RESOLUTION NO. 07-2021

CONDITIONALLY APPROVING AN AMENDMENT TO THE 2004-APPROVED MAJOR PHASE FOR BLOCKS 8- 10A, AND PARKS P18, P19, AND P20, AND A BASIC CONCEPT AND SCHEMATIC DESIGN FOR MISSION BAY SOUTH BLOCK 9A, TO DEVELOP AN AFFORDABLE HOUSING PROJECT OF APPROXIMATELY 148 FOR-SALE UNITS; PROVIDING NOTICE THAT THESE APPROVALS ARE WITHIN THE SCOPE OF THE MISSION BAY REDEVELOPMENT PROJECT APPROVED UNDER THE MISSION BAY FINAL SUBSEQUENT ENVIRONMENTAL IMPACT REPORT (“FSEIR”), A PROGRAM EIR, AND ARE ADEQUATELY DESCRIBED IN THE FSEIR FOR THE PURPOSES OF THE CALIFORNIA ENVIRONMENTAL QUALITY ACT (“CEQA”); AND, ADOPTING ENVIRONMENTAL REVIEW FINDINGS PURSUANT TO CEQA; MISSION BAY SOUTH REDEVELOPMENT PROJECT AREA

Exhibit A: Mission Bay South Block 9A Basic Concept / Schematic Design Submittal

Mission Bay Block 9A

EAST ELEVATION / TERRY FRANCOIS BLVD ELEVATION

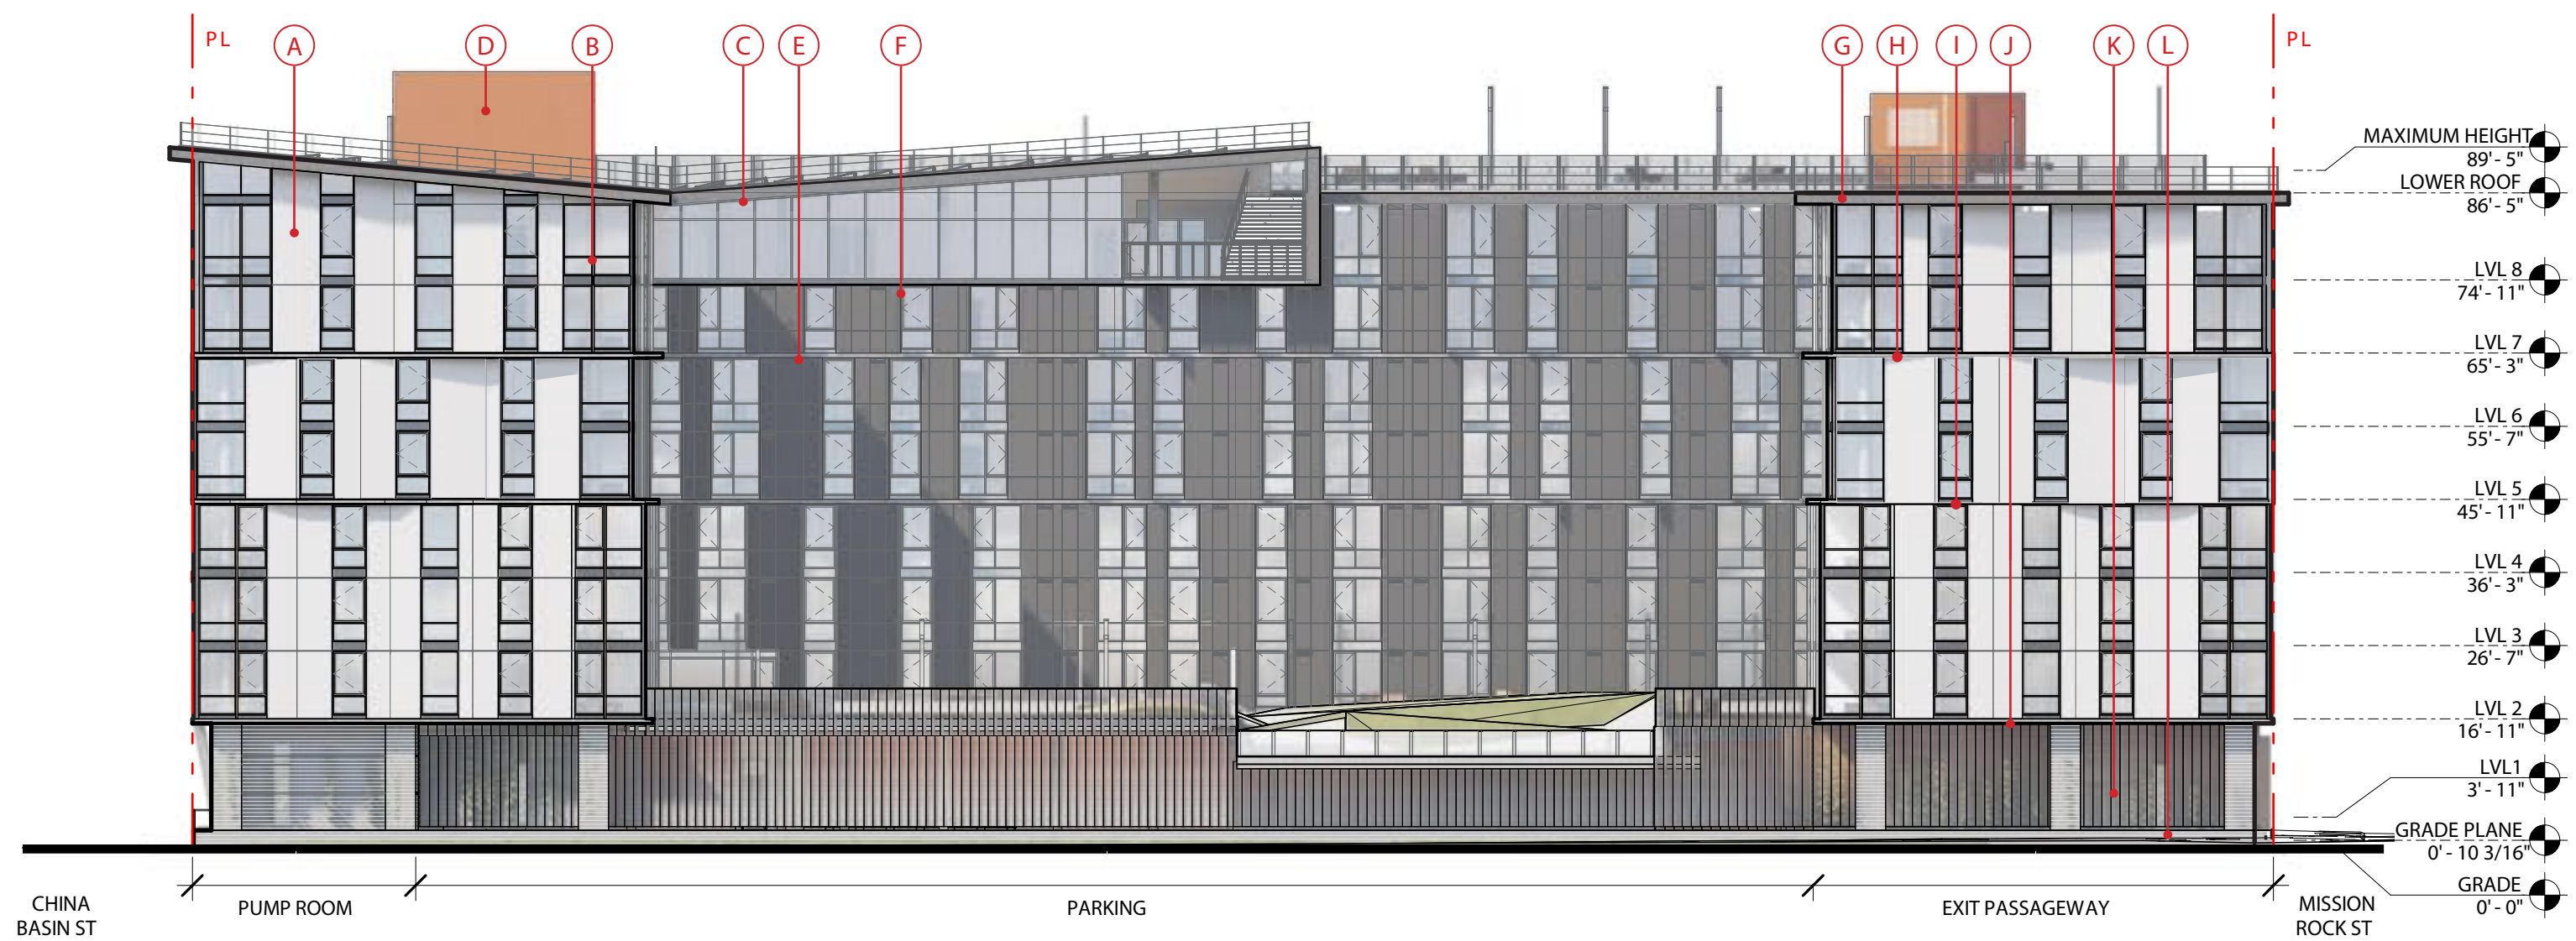
- a. Screening with appropriate percentage of perforation, at the ground floor frontage along Terry François Boulevard that will allow ventilation and light to percolate through, indicating activity behind the screening and engaging the landscape of P19 by avoiding effect of blank wall.

A_WEST FACADE_BIKE ROOM

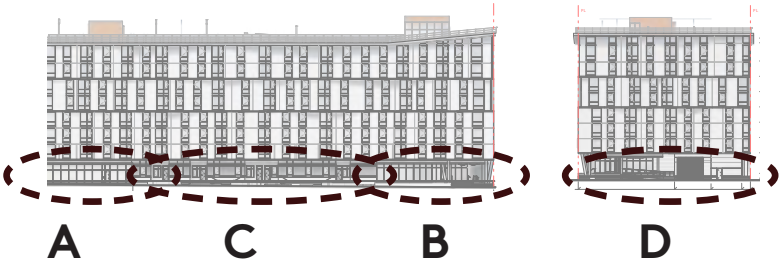
3. Bike Room: Further study the interior layout of Bike Room at the ground floor corner of Bridgeview Way and Mission Rock Street that enables screening of bike parking facilities while allowing transparency at the storefront glazing.

A. ANODIZED ALUMINUM PERFORATED SUNSHADES AT EAST FACADE

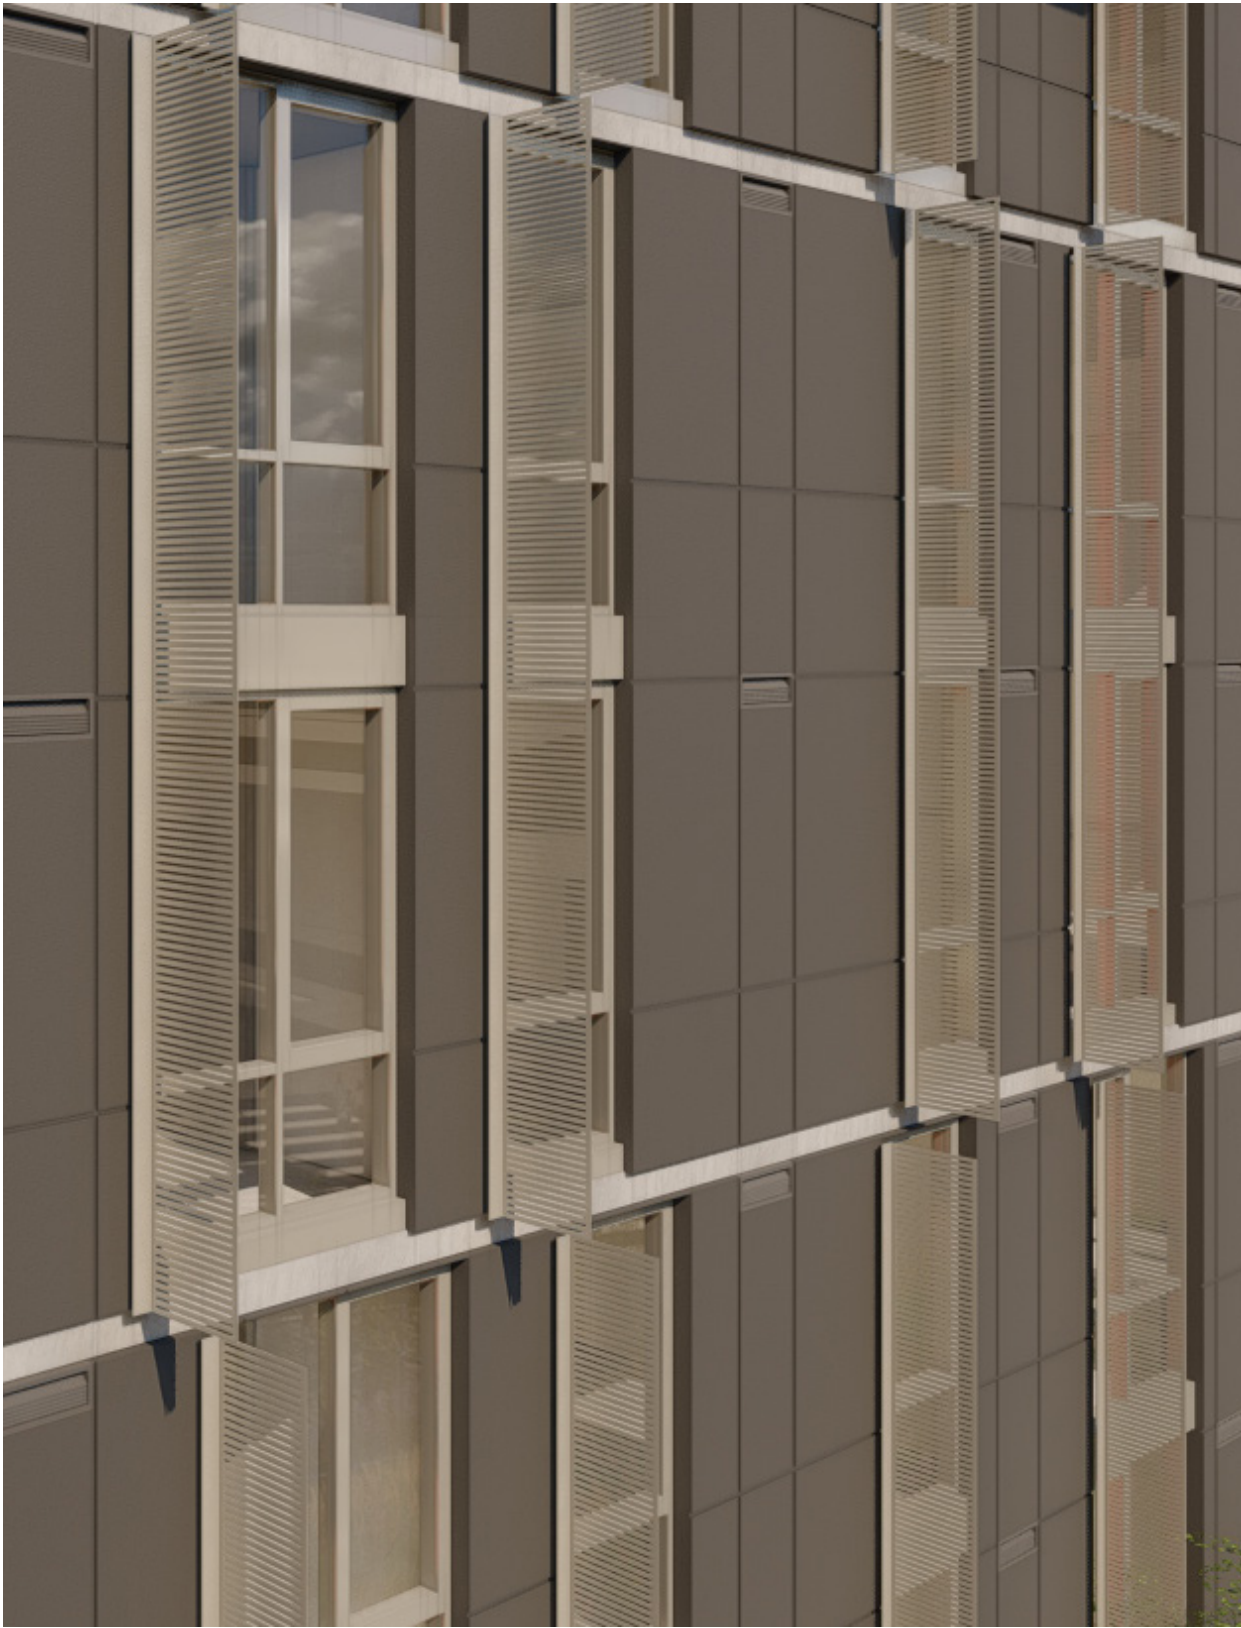
- b. Screening (sunshade) for windows with appropriate percentage of perforation on the Terry François Boulevard façade.
 - c. Any mechanical equipment and/or utilities facilities, including connections and meters on the rooftop and ground floor shall be architecturally screened from the roof and street level respectively.
